Owner Occupied and Scattered Site Rehabilitation Programs

**Addendum # 2
January 6, 2017**

Project # 1183 Property Address: 9 East Avenue, Milford, CT

Addendum #2 – Attachment 1

JOB NO.	DRAWING NUMBER	SHEET
33-262-1183	BASEMAP 33-262-1183.dwg	A-1.1

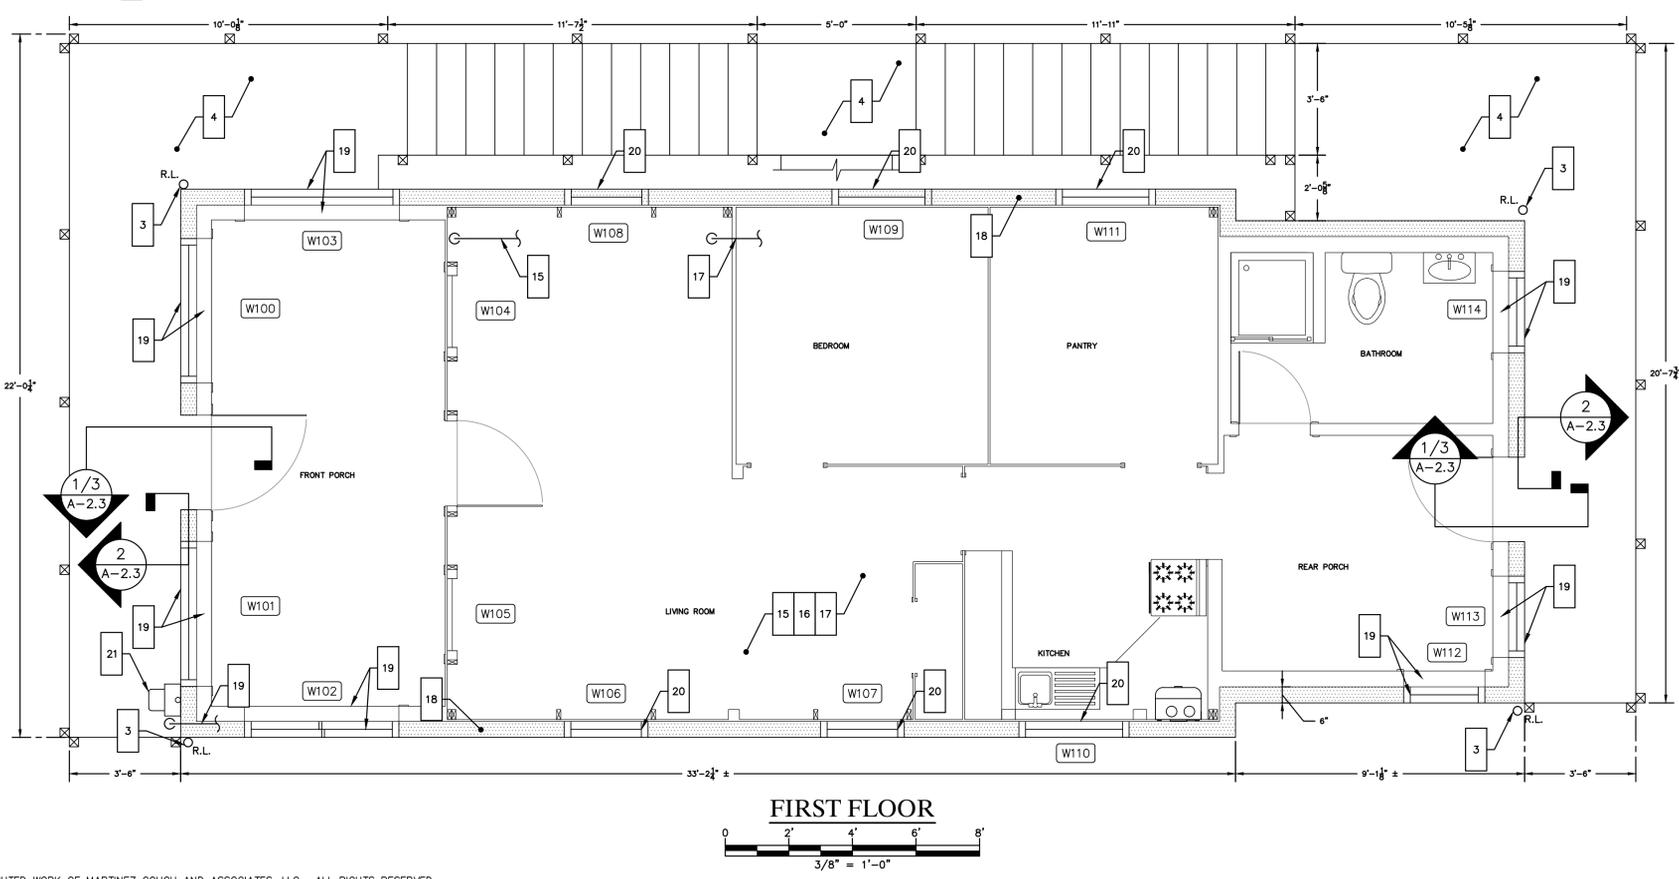
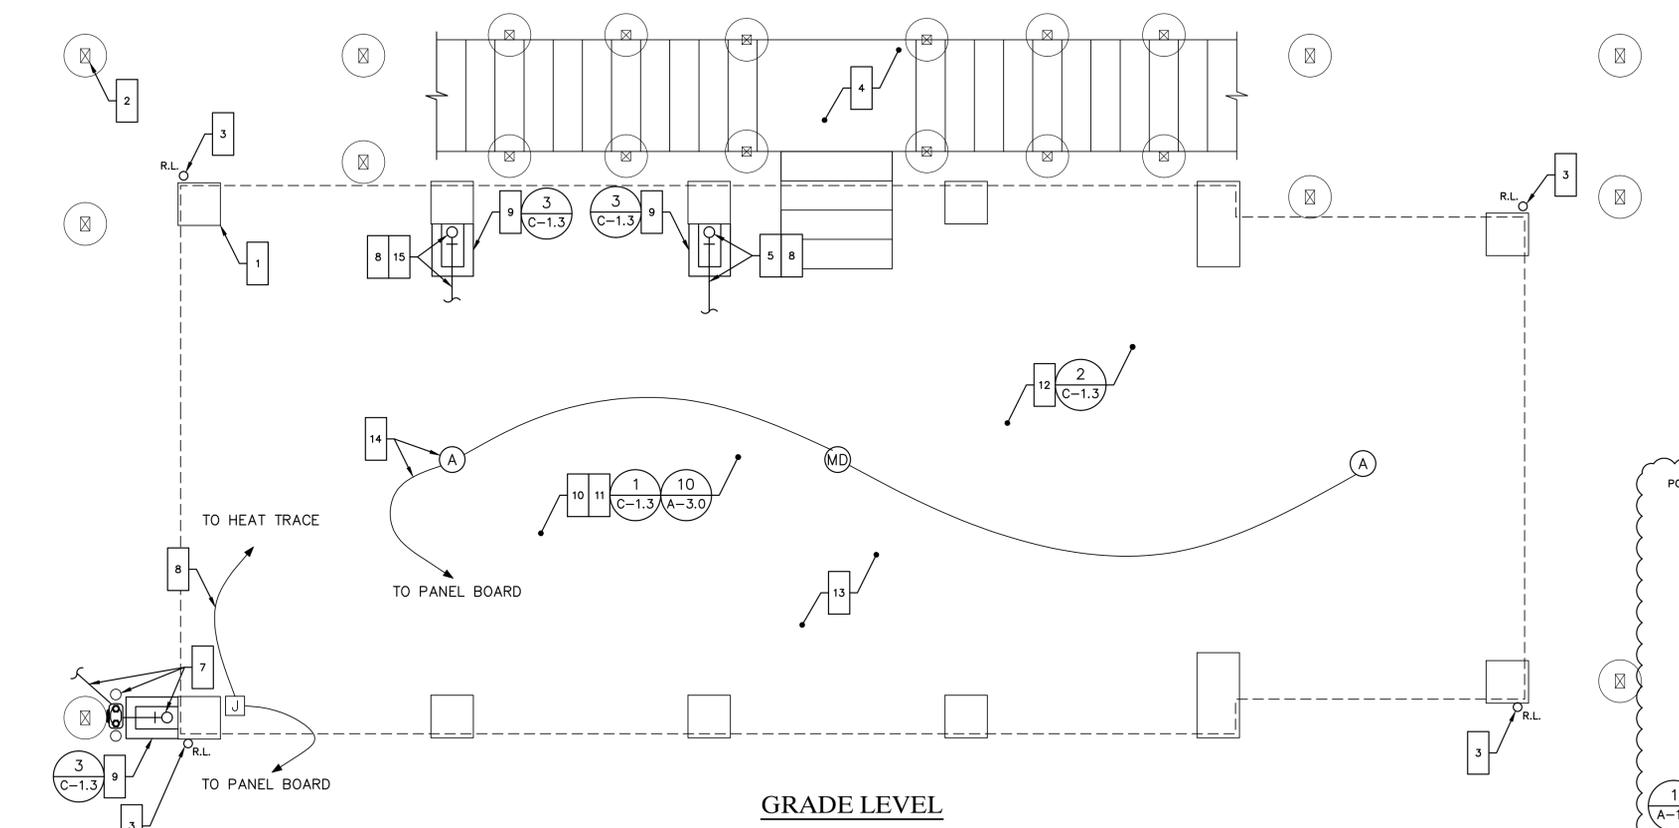
1. Replace drawing sheet A-1.1 with Attachment 1 of this addendum, hard wired smoke and carbon monoxide alarm system is incorporated into project scope of work, revisions to drawing sheet are clouded and labeled.

- 14 FURNISH AND INSTALL LIGHTING FIXTURES AND MOTION DETECTION OPERATION AT UNDERSIDE OF ELEVATED HOUSE. FURNISH AND INSTALL NEW 20 AMP CIRCUIT ON EXISTING PANEL BOARD. CABLE TO BE NON-METALLIC SHEATHED TYPE NM-C, PROVIDE 2-#12, 1-#12 GROUND. PROVIDE ELECTRIC METALLIC TUBING AS CONDUIT FOR CABLING AT BUILDING UNDERSIDE FROM FIXTURES TO NEW SWITCH ON FIRST FLOOR OF HOUSE. FURNISH AND INSTALL SMOKE/CARBON MONOXIDE ALARMS AND NEW CIRCUIT
